NUCLEAR ENERGY INSTITUTE

Subject: Submittal of NEI 12-02, Revision 0, Industry Guidance for Compliance with NRC Order EA-12-051, "To Modify Licenses with Regard to Reliable Spent Fuel Pool Instrumentation" and Comments on NRC Interim Staff Guidance Compliance with Order EA-2012-051, Reliable Spent Fuel Pool Instrumentation (JLD-ISG-2012-03) (77 Fed. Reg. 33780; Docket ID NRC-2012-0067)

The Nuclear Energy Institute,¹ on behalf of the nuclear industry, is pleased to submit to the U.S. Nuclear Regulatory Commission (NRC) for review and endorsement, NEI 12-02, Revision 0, *Industry Guidance for Compliance with NRC Order EA-12-051, "To Modify Licenses with Regard to Reliable Spent Fuel Pool Instrumentation,"* dated July 2012 (Attachment 1). To aid in identifying the changes, Attachment 2 is a line-in/line-out formatted version of NEI 12-02, Revision 0.

Figure 1

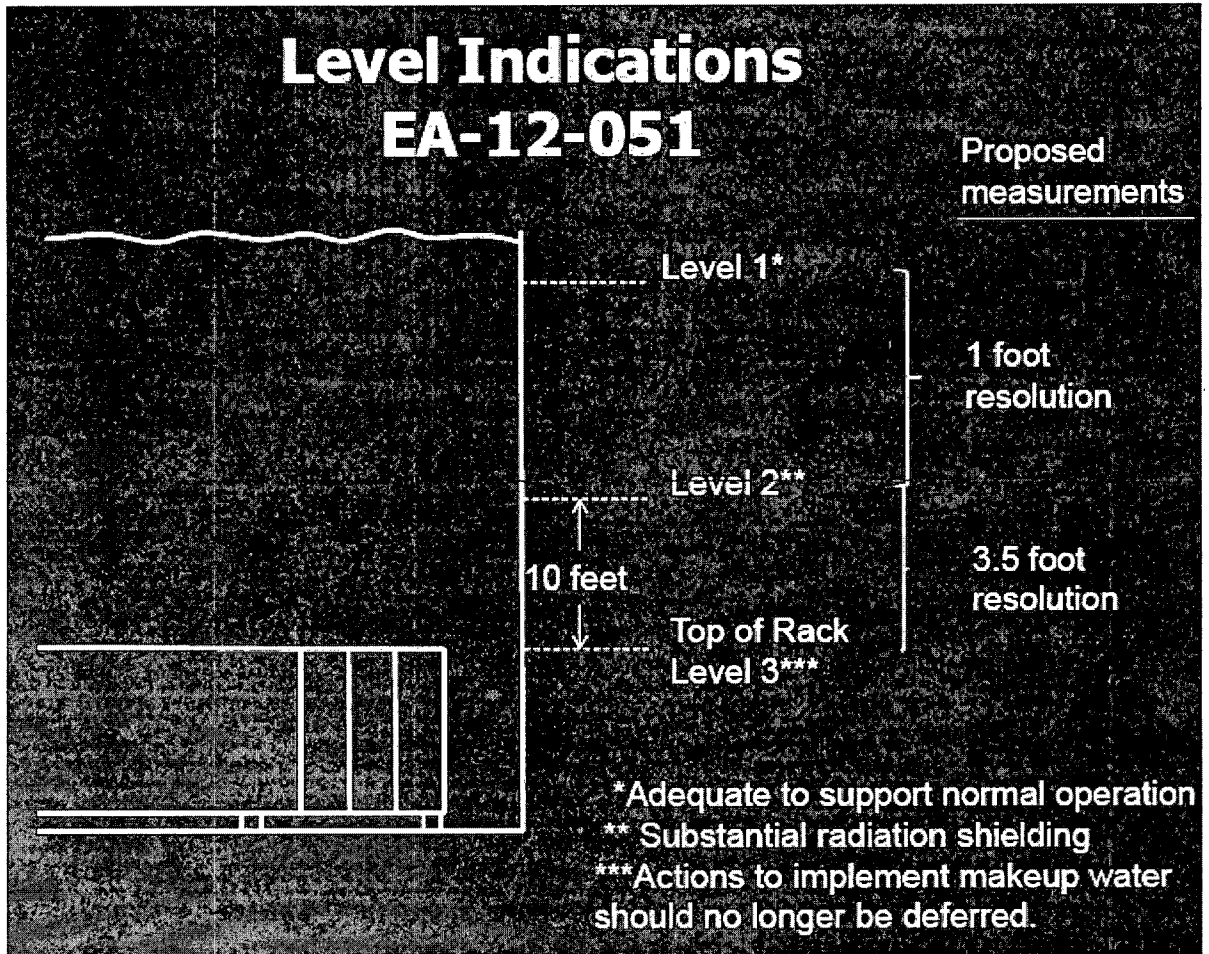
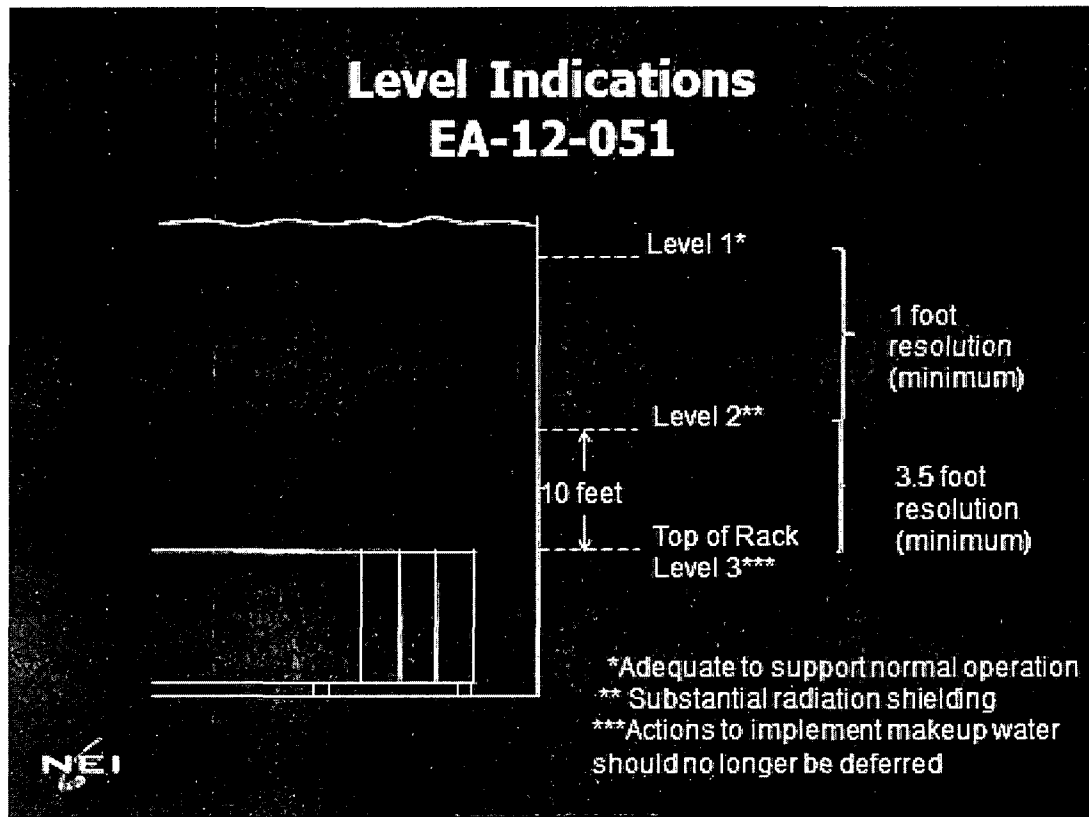
The three critical ~~points~~levels that must be monitored in a spent fuel pool are discussed below. It should be noted that continuous indication from a single instrument over the entire span from ~~PointLevel 1 to PointLevel 3~~ is not required, but the set of instruments used to monitor the entire span is necessary to satisfy the requirements for the primary or backup instrument channel (refer to Figure 1 below).

A visual representation of ~~the monitoring level points~~levels 1, 2, and 3 ~~is~~ and the associated resolution requirements for monitoring between the points are presented in Figure 1. The minimum resolution requirements apply to the separation distance between level indications and support development of appropriate response procedures. These requirements are separate from the instrument channel design accuracy discussed in section 3.

The instrument channels shall maintain their designed accuracy following a power interruption or change in power source without recalibration. Accuracy should be maintained within the resolution identified in Figure 1 and consider SFP conditions, e.g., saturated water, steam environment, or concentrated borated water. Additionally, instrument accuracy should be sufficient to allow trained personnel to determine when the actual level exceeds the specified lower level of each indicating range (levels 1, 2, and 3) without conflicting or ambiguous indication.
